Form 3160-5
(June 2019)UNITED STATES
DEPARTMENT OF THE INTERIOR
BUREAU OF LAND MANAGEMENTFORM APPROVED
OMB No. 1004-0137
Expires: October 31, 2021**SUNDRY NOTICES AND REPORTS ON WELLS**
Do not use this form for proposals to drill or to re-enter an abandoned well. Use Form 3160-3 (APD) for such proposals.5. Lease Serial No. **MULTIPLE**6. If Indian, Allottee or Tribe Name
MULTIPLE**SUBMIT IN TRIPLICATE - Other instructions on page 2**

EOG Resources Inc. (EOG) respectfully requests the execution of the variance for Wellhead break testing and offline cementing for the following wells, as outlined below (and with the additional Offline Cement Intermediate Operational Procedure):

30-015-47723 Ross Draw 17 Fed Com #710H

30-015-47722 Ross Draw 17 Fed Com #711H

Revised Wellbore

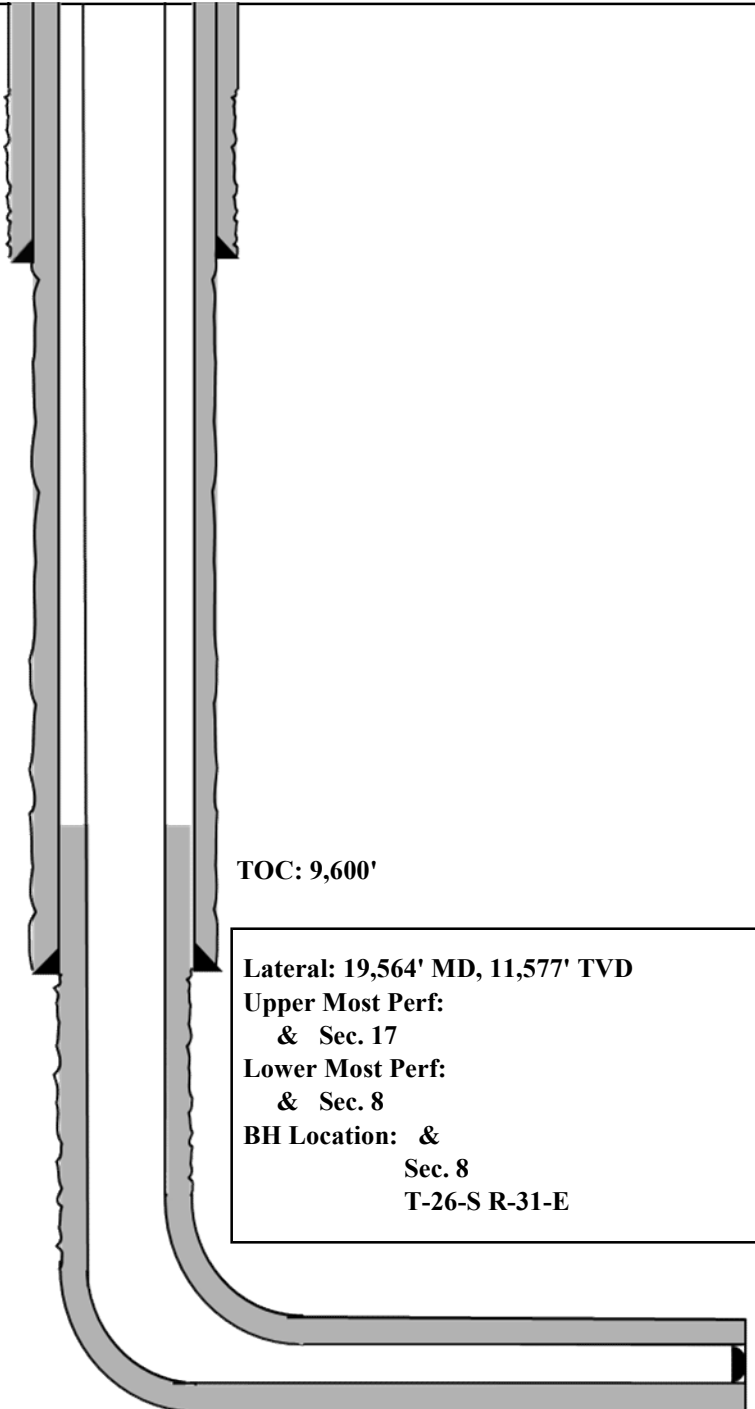
EOG also requests the surface casing change from 40# to 36#, and the curve/lateral production hole size changed to 6-3/4" (from 8-1/2" taper).

Bit Size: 12-1/4"
 9-5/8", 36#, J-55, LTC,
 @ 0' - 1,310'

Bit Size: 8-3/4"
 7-5/8", 29.7#, HCP-110, FXL,
 @ 0' - 10,100'

Bit Size: 6-3/4"
 5-1/2", 20#, P110-EC, DWC/C IS MS,
 @ 0' - 9,600'

5-1/2", 20#, P110-EC, Vam Sprint SF,
 @ 9,600' - 10,100'

5-1/2", 20#, P110-EC, DWC/C IS MS,
 @ 10,100' - 19,564'

Figure 1: Cameron TA Plug and Offline Adapter Schematic

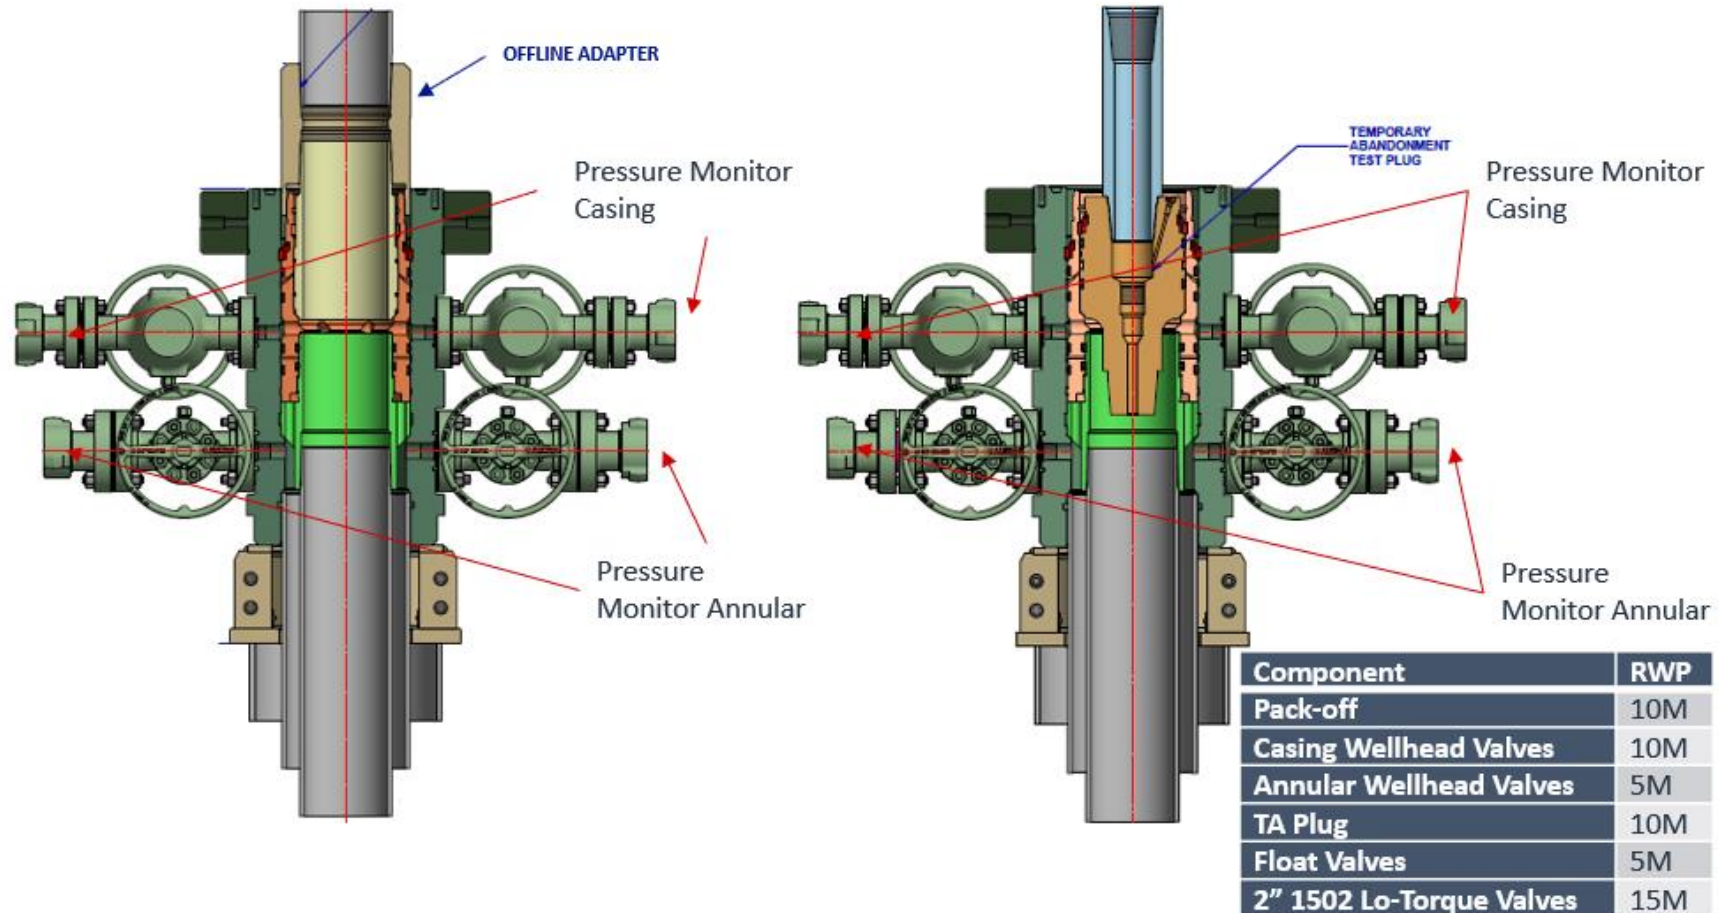
- c. Return line schematics can be seen in Figure 3.
10. Remove TA Plug from the casing.
11. Install offline cement tool.
 - a. Current offline cement tool schematics can be seen in Figure 1 (Cameron) and Figure 2 (Cactus).

Figure 4: Rig Placement Diagram

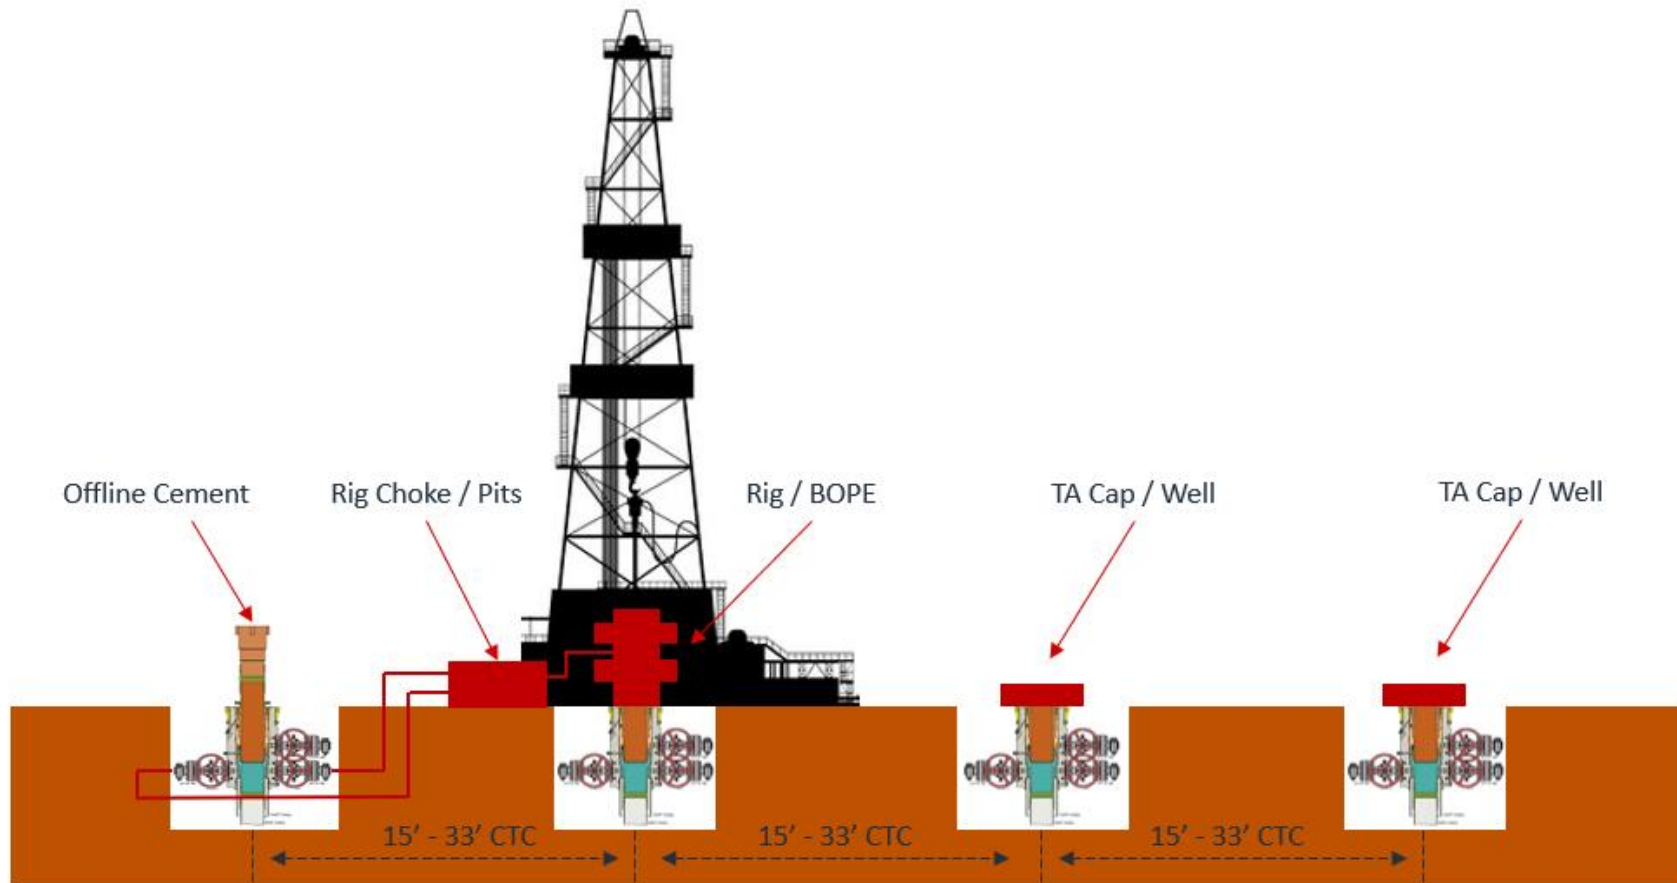
- e. Diagram for rig positioning relative to offline cementing can be seen in Figure 4.
9. Rig up return lines to take returns from wellhead to pits and rig choke.
